PLANNING DIVISION STAFF REPORT

August 29, 2022

Project Address: 1303-1323 Williamson Street and 401-409 S Baldwin Street
Application Type: Demolition Permit, Conditional Use, & Certified Survey Map Referral
Legistar File ID # [72803](#), [72804](#), and [72772](#)
Prepared By: Chris Wells, Planning Division
Report Includes Comments from other City Agencies, as noted
Reviewed By: Kevin Firchow, AICP, Principal Planner

Image 1: The seven parcels and five buildings which make up the subject site. The three buildings proposed for demolition are hatched.

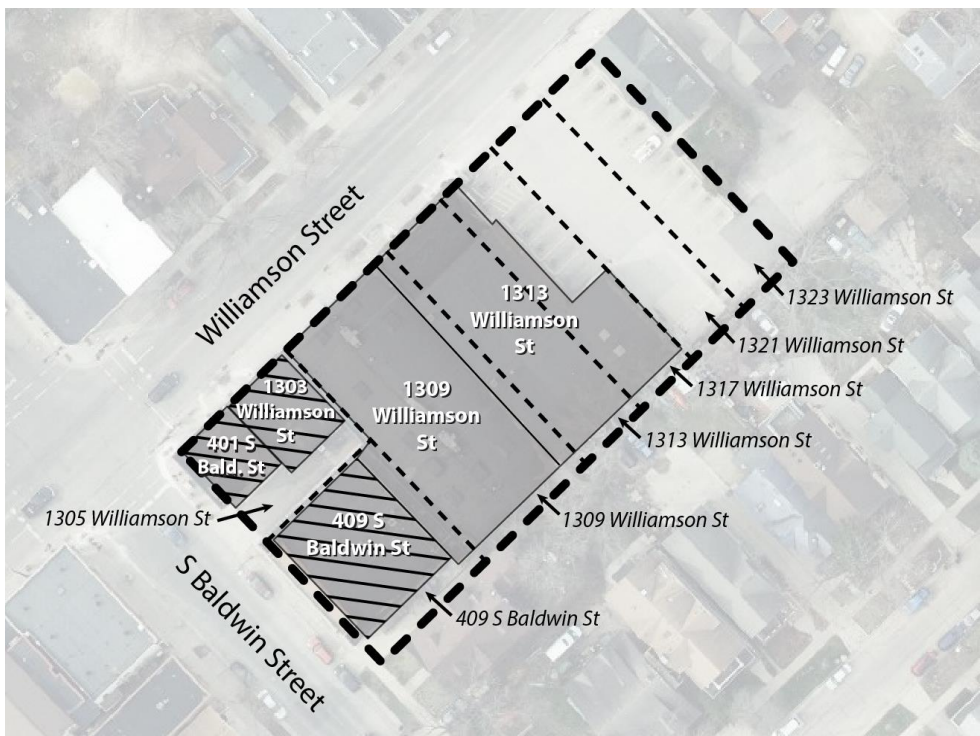
The subject site is comprised of seven parcels developed with five buildings. The three westernmost commercial buildings - addressed as 1303 Williamson Street, and 401 and 409 S Baldwin Street (and hatched in Image 1, below) - are proposed for demolition. The three buildings to be razed are summarized under the ‘Existing Conditions and Land Use’ subsection in the preceding section of this report. [Photos](#) of the interior and exterior of the buildings are attached to the demolition permit file, ID [72803](#).
